RE: Petition No. 1226
Towantic Switching Station and Line Modification Project

To incorporate the FAA's conditions of lighting into the Project design documents, Eversource proposes to add notations on Mapsheets 21-23, which depict the structures affected by the FAA determinations. The modified Mapsheets 21-23 are included in Attachment E.

BUNKER HILL - OXFORD
115KV TRANSMISSION
FAA LIGHT & SOLAR PANEL ARRANGEMENT
OXFORD/WATERBURY/MIDDLEBURY, CT

REVISED PETITION MAPSHEET 20-22

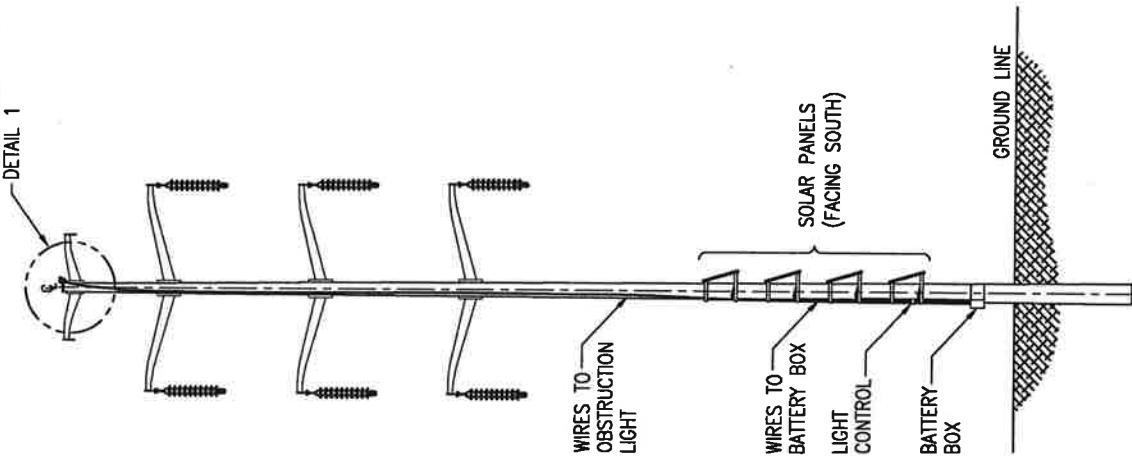
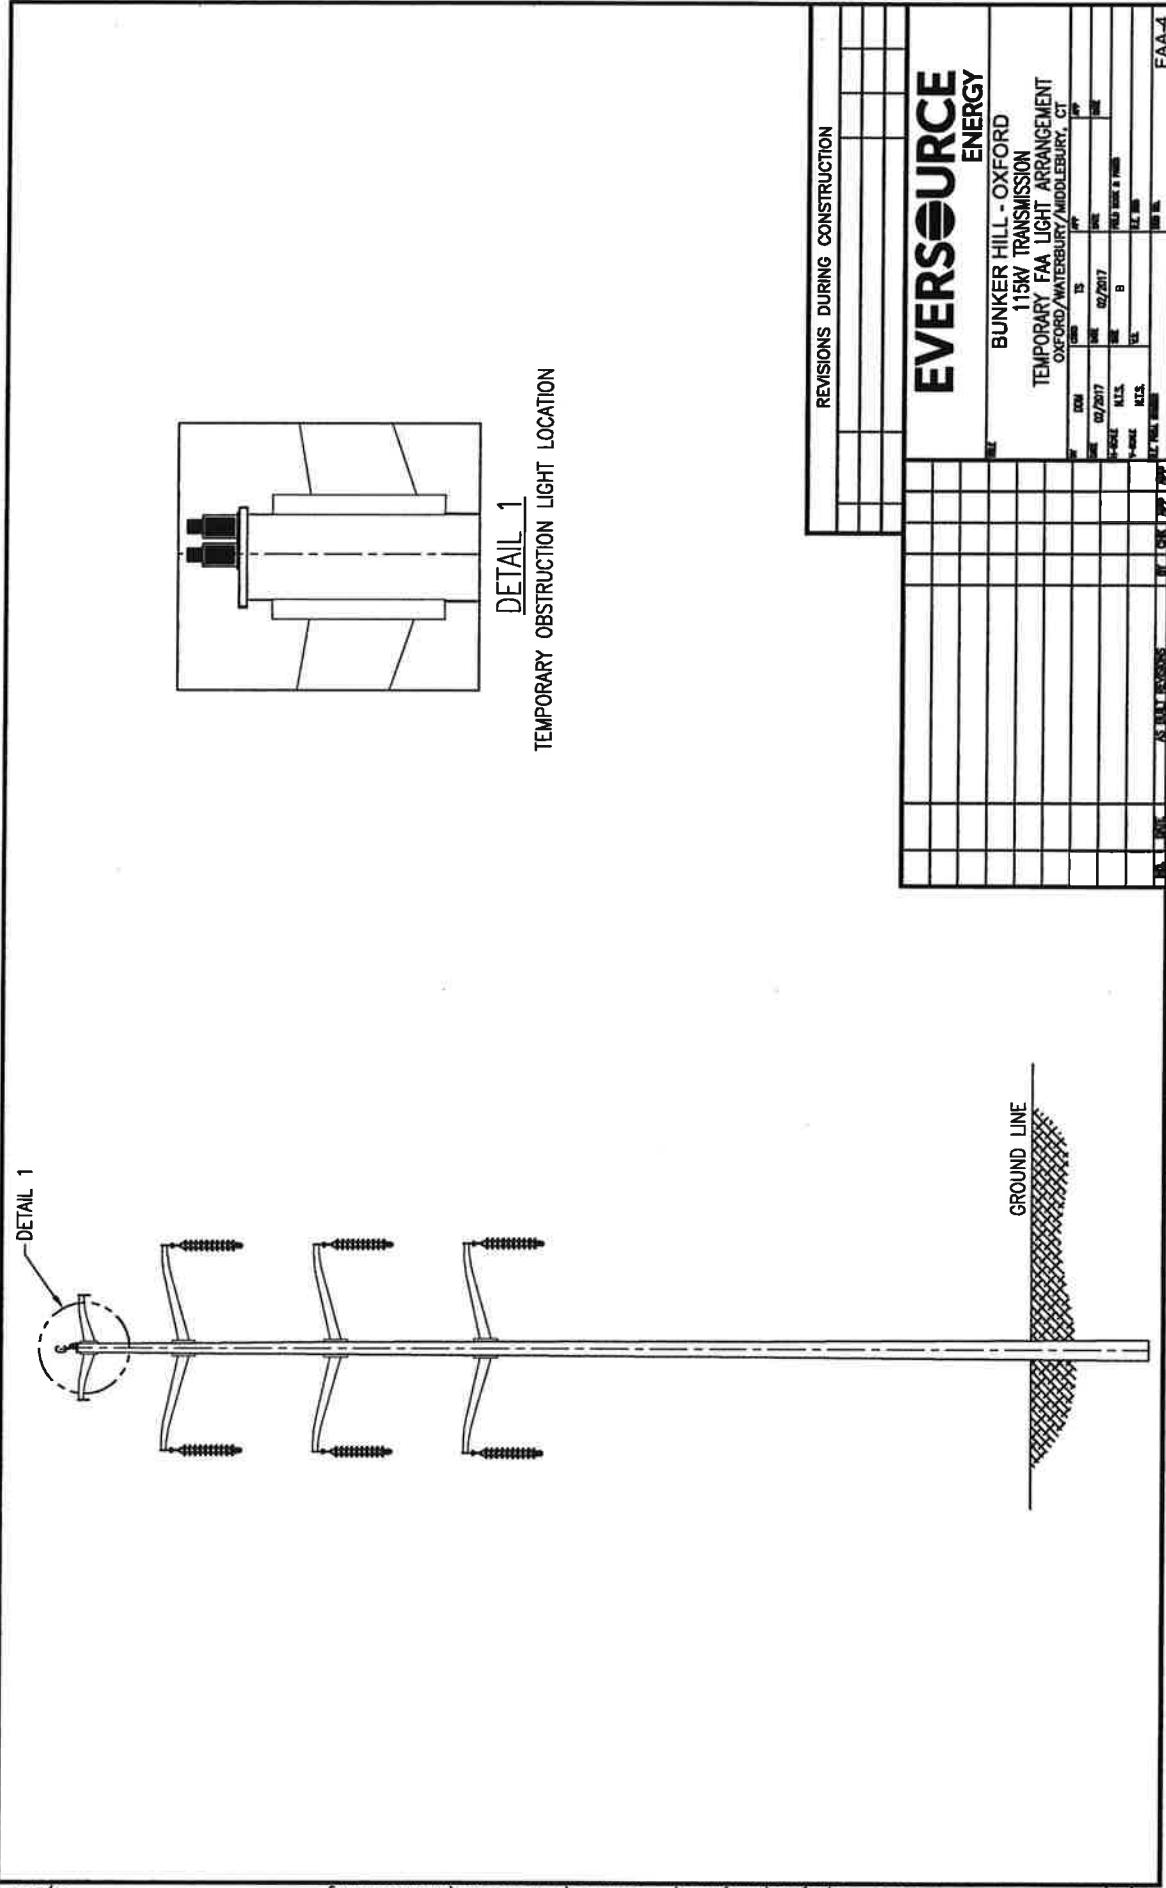
Attachment B contains cross section drawings FAA-3 and FAA-4 which illustrate the design of the temporary and permanent aviation lighting. Table 1 in Attachment C provides specifications regarding the FAA recommended lighting and identifies the transmission line structures on which lighting will be provided. Attachment D provide photographs of representative examples of solar with battery backup and solar powered aviation warning lights on structures and the warning lights planned for the line structures will be the same, or similar to, these lights.

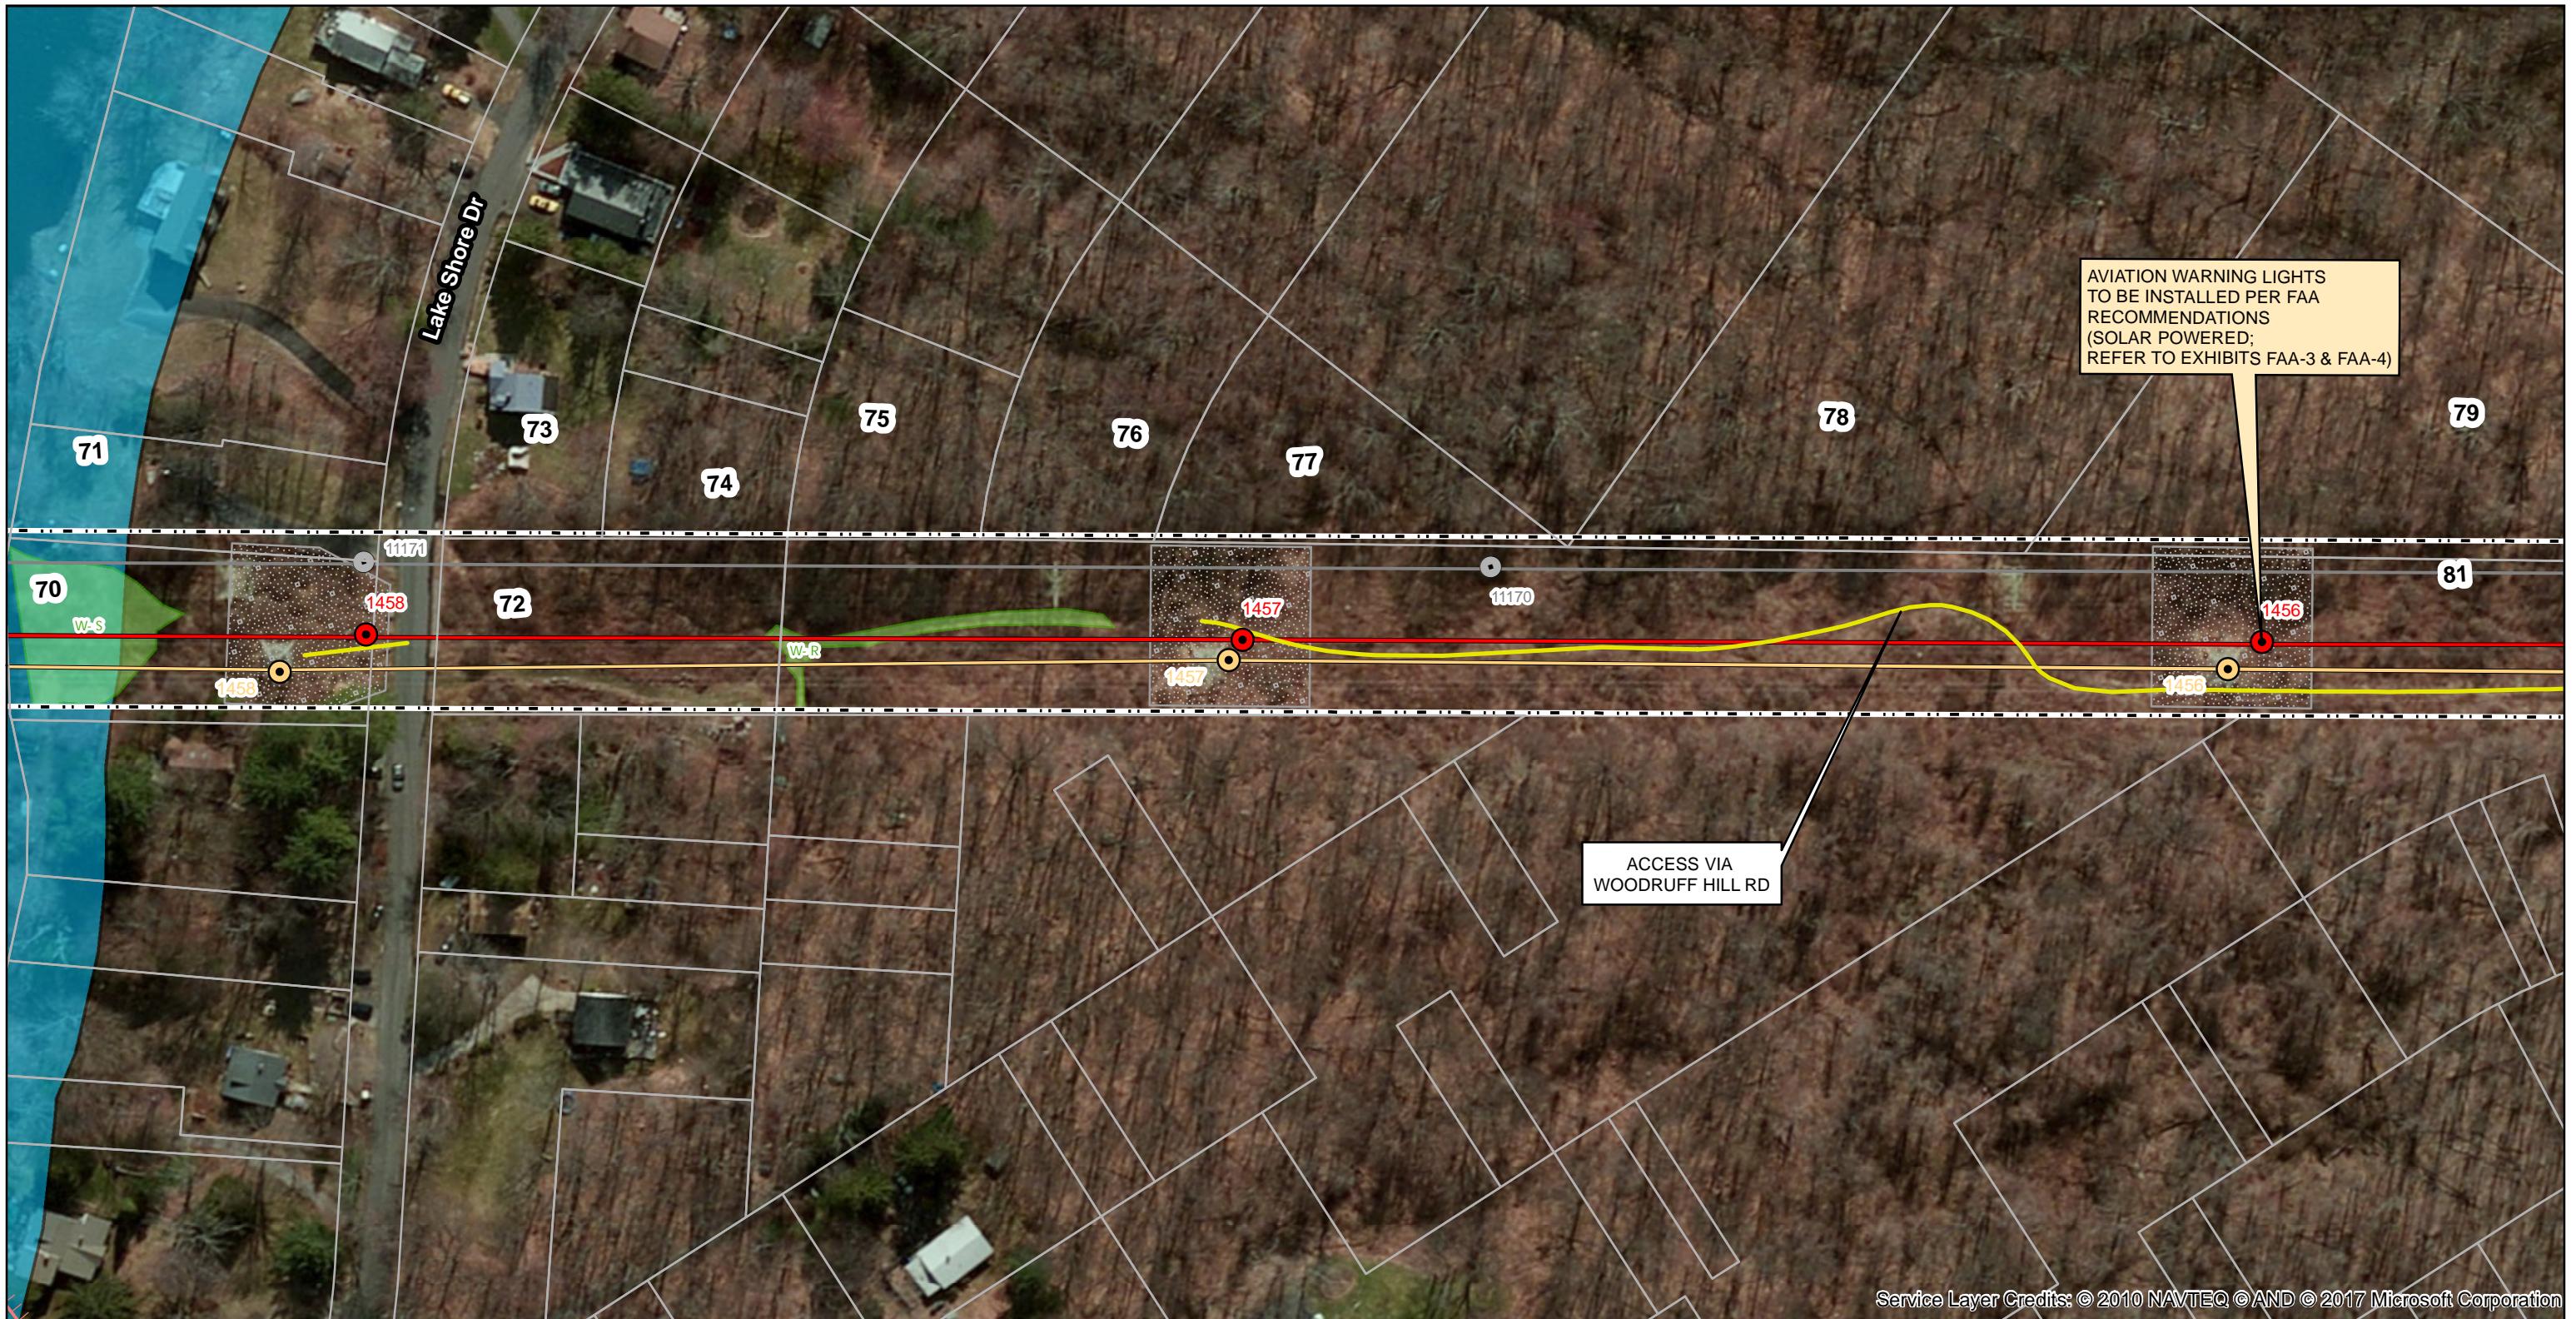
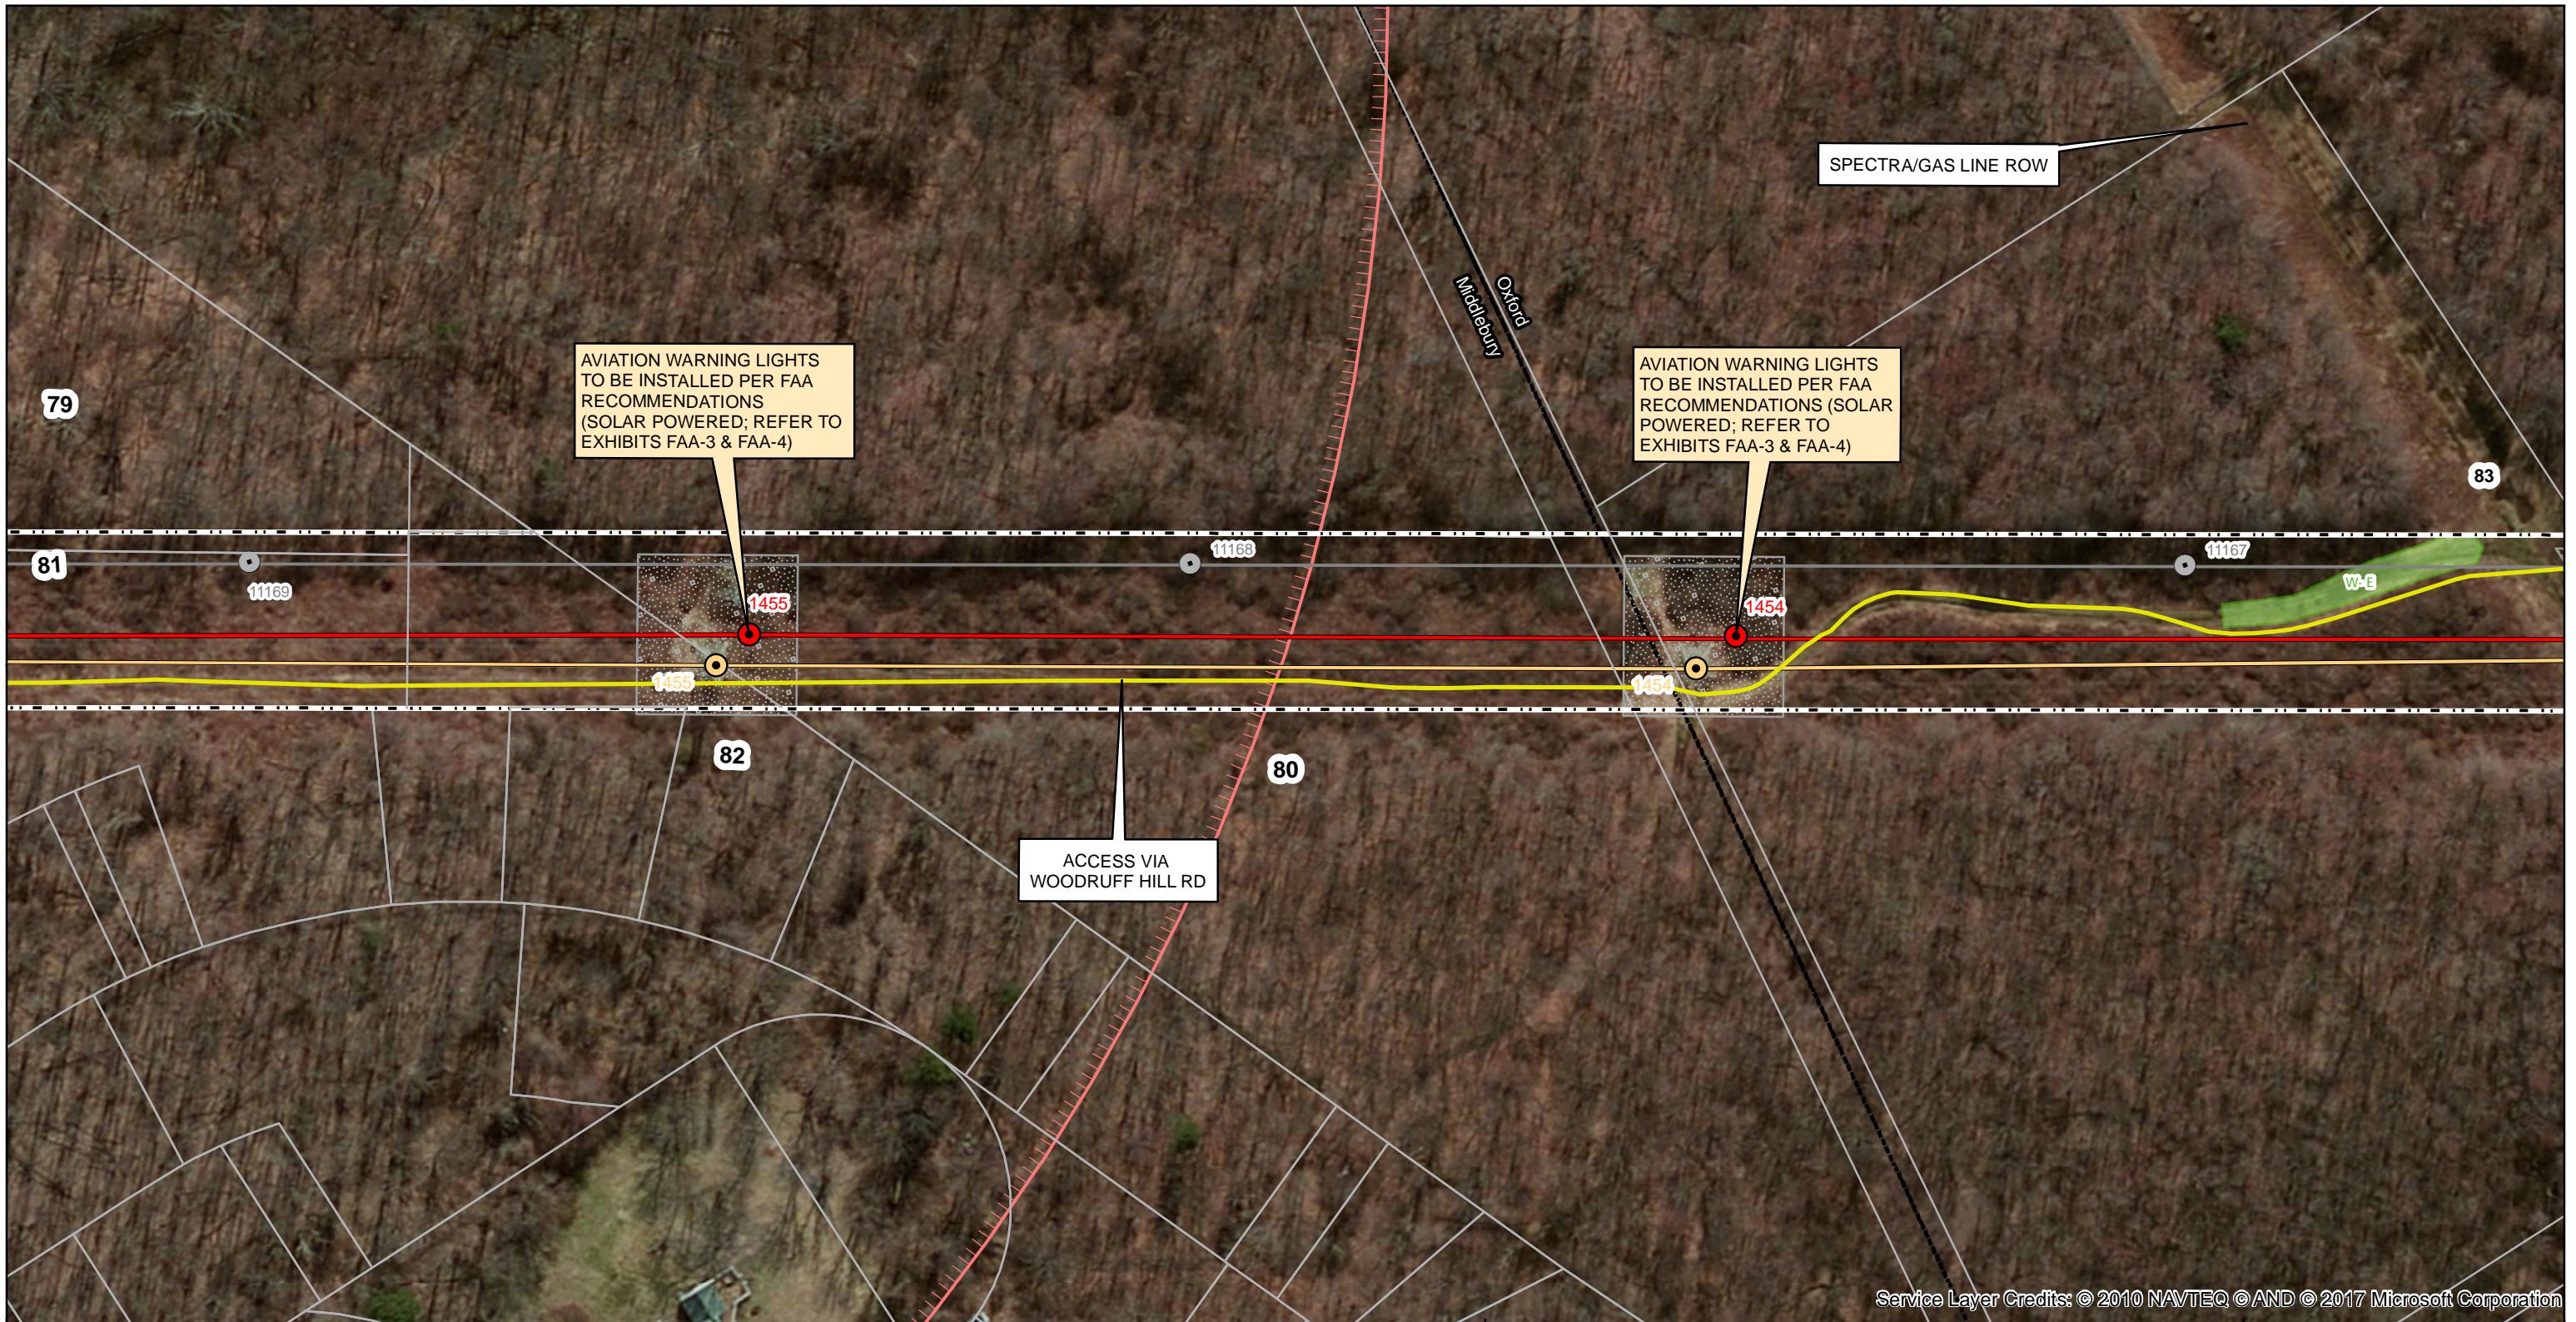
INCORPORATING LIGHTING MODIFICATIONS
